Permit Number: 081399

has permission to Amendment to permit #080527 Change Floor, Floor Plan & building addition

City of Portland, Maine - Building or Use Permit Application

Past Use: Commercial - restaurant - Amendment to permit #080527	Proposed Use: Commercial - restaurant - Amendment to permit #080527 - Change Facade, Floor Plan & build an addition	Permit Fee: \$30.00	Cost of Work: \$30.00	CEO District: 3
Proposed Project Description: Amendment to permit #080527 Change Facade, Floor Plan & build an addition		FIRE DEPT: <input checked="" type="checkbox"/> Approved <input type="checkbox"/> Denied <i>See conditions</i>	INSPECTION: Use Group: <i>A-2</i> Type: <i>2B</i> <i>IBC-2003</i>	
		Signature: <i>Greg Cass</i>	Signature: <i>EL</i> 12/23/08	
PEDESTRIAN ACTIVITIES DISTRICT (P.A.D.)				
Action: <input type="checkbox"/> Approved <input type="checkbox"/> Approved w/Conditions <input type="checkbox"/> Denied				
Signature: _____ Date: _____

Ann Machado - Revised site plan of 1140 Brighton Ave

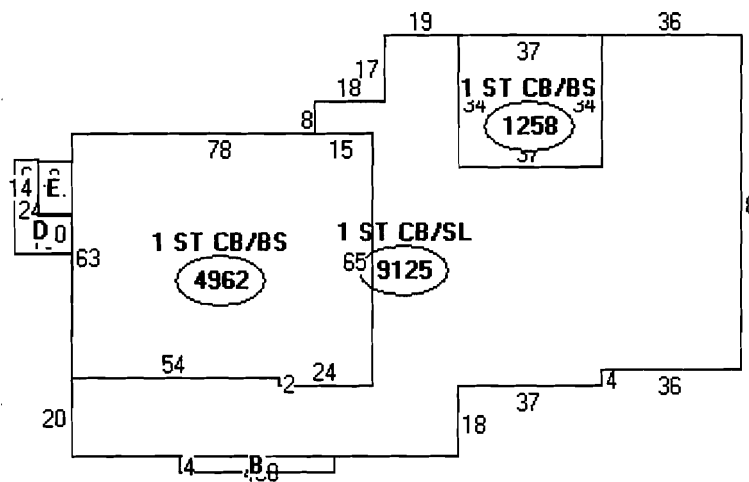
11/12/2008-amachado: Received revised siteplan. Addition is 7' from property line. Needs to be a minimum of 10'. Spoke to Bob Greenlaw. He said that it was replacing a previous larger outbuilding but I can find no record of it on file. The new addition has to meet the rear setback.

11/17/2008-amachado: Spoke to Missy from Ocean Park Land Surveying. She wanted to know what the holdup was on the permit. I told her that the addition does not meet the 10' rear setback I also told her that I had spoken to Bob Greenlaw about this on Nov 12. We need a revised siteplan that shows that the addition is meeting the rear setback. We also need revised construction details for the new addition. When we receive a revised siteplan there will have to be a site plan exemption applied for.

Rear Yard - 10' min. - 10' shown & set back.
